DEVELOPMENT REVIEW COMMITTEE (DRC) COMMENT REPORT

PROJECT NAME: Townhomes at River Gardens

CASE NUMBER: PLN-SITE-19100004

REQUEST: Site Plan Level II Review: 19-Unit Townhouse
Development

Examples of Façade Articulation, Mitigation of Massing Elements to address Building Scale, provisions for Light and Air, Walkable Neighborhood Street Grid with Shaded Sidewalks and Pedestrian Entry Features:

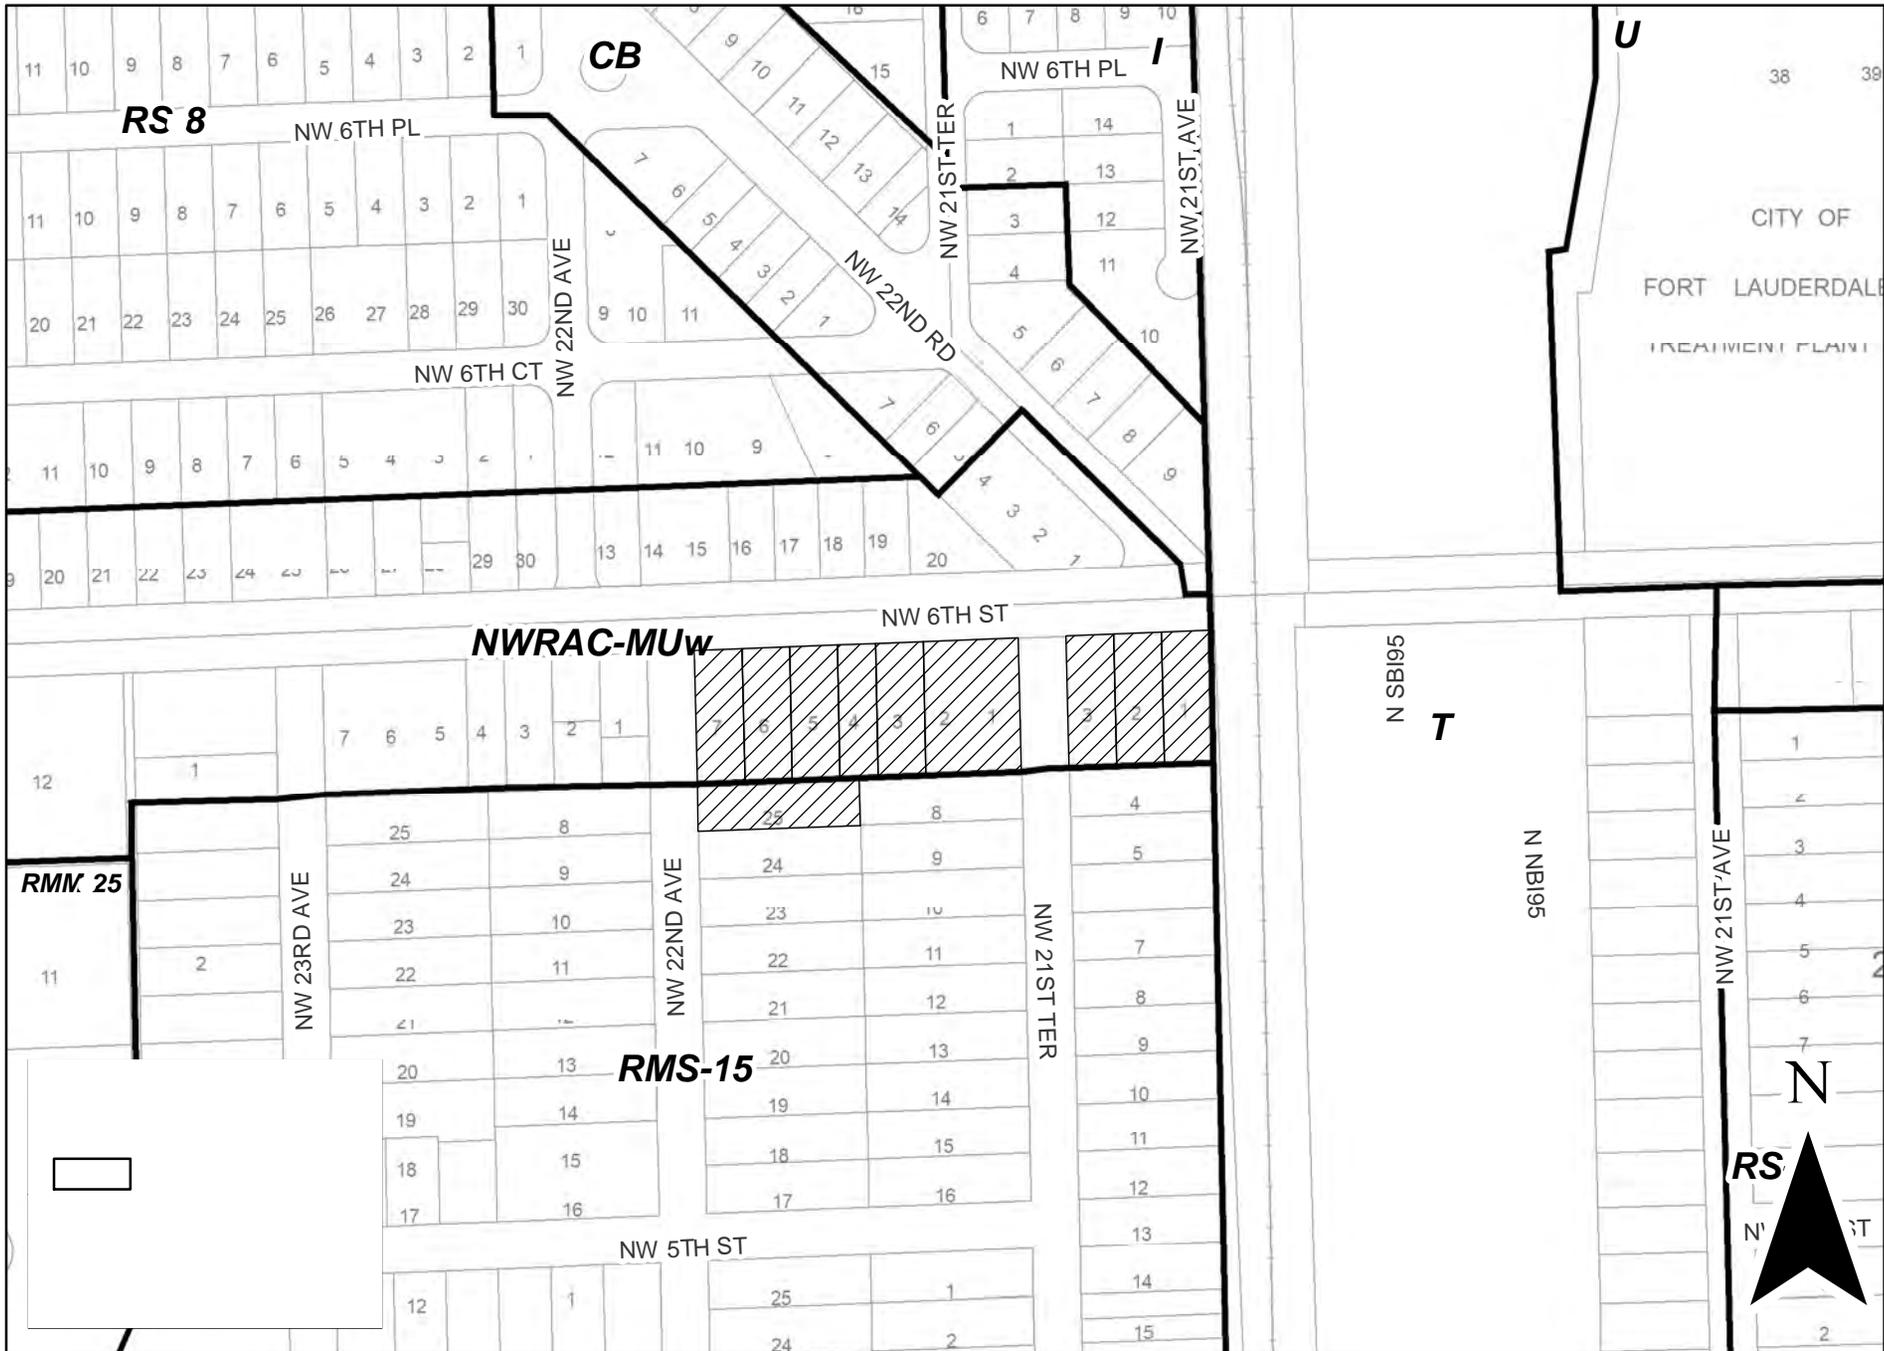
- c. Consider breaking up the massing by rearranging the townhouses to groups of four or five units per group to allow for additional light and air in the proposed development.

- c. Provide building massing and add façade articulation to the buildings facing NW 6th Street and NW 22nd Avenue.
12. Provide details of the fence to indicate compliance with Section 47-18.33.B5.9, *Fence Requirements*, and consider the visual impact of the fence bordering the development. Fencing should be placed and designed in a way that relates to the public realm/street and project. Consider providing transparency or a finish that articulates the building behind and provides safety through visibility along the street.
